**Planning Application Ref:** AW/246/19/PL

**Location:** Land Adjacent to 34 Wakefield Way Aldwick PO21 3RS

**Description of works:** Erection of 1 No. 2 storey end of terrace house

**Comments on Application:**

**June 2013 – Severe crown loss (40%) following loss of limb to lower trunk**

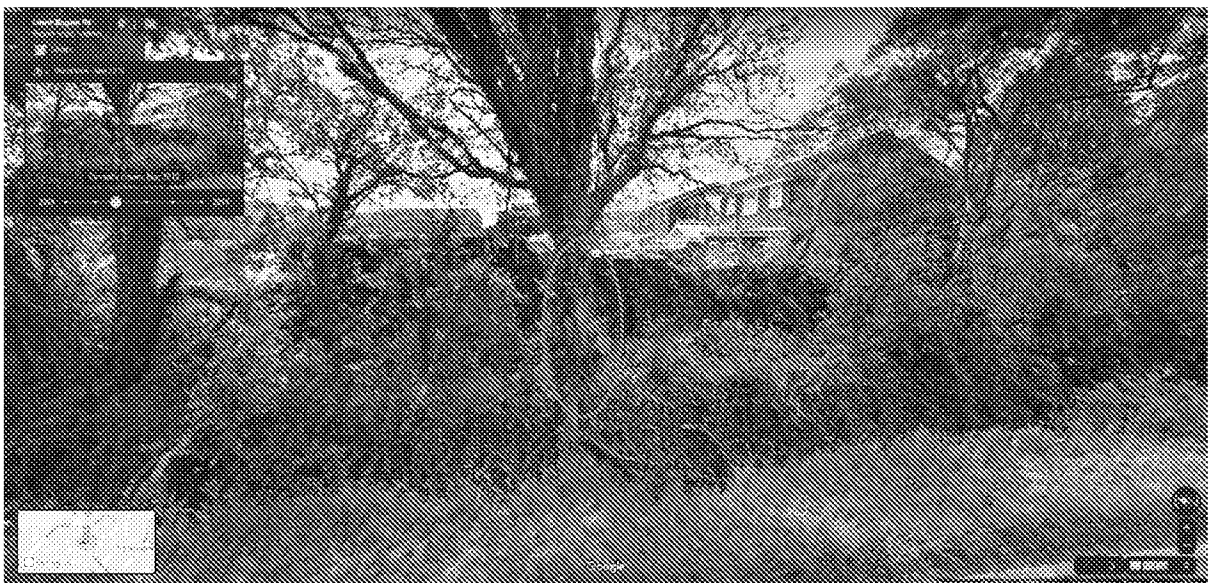
- The Tree Survey data is comprehensive and accords with the requirements of BS5837:2012. I am broadly in agreement with the retention category ratings for on and off-site trees, although there is insufficient evidence to support the Category C rating applied to oak T05. This may be a Category B tree – in any event, its long-term retention is highly desirable as based on the information provided and from my own limited ground level assessment, this tree could theoretically be viable for in excess of 100years.

- T05 is one of several large, mature/maturing English oak that are major landscape components defining the verdant character of the area. As if by chance, they are evenly spaced and on opposite sides of the road, such that they present both individually and as constituents of a disparate group. Their crowns are relatively unmodified so are visually attractive from many aspects. The loss of any one of these trees would no doubt be keenly felt by local residents and regular visitors alike.

*We agree with the comments regarding the value of the tree T05 within the wider landscape context and amenity historically, however due to severe damage to the main trunk with subsequent 40% loss of crown (as detailed in our Existing Tree Schedule and Schedule of Tree Works) the category has been reclassified from B to C based on its Arboricultural Condition. There is also evidence of exposure to structural roots following ditch clearance.*

*Between the June 2011 and May 2012 a large part of the tree canopy (approx. 40%) was lost due to a probable compression fork fracture of one of the main stems located to the northern aspect as illustrated by Google Earth photography below. Due to significant unoccluded wounding and exposure of the heartwood the extent of the damage is such that it is considered unreasonable to apply a viability in excess of 100 years.*
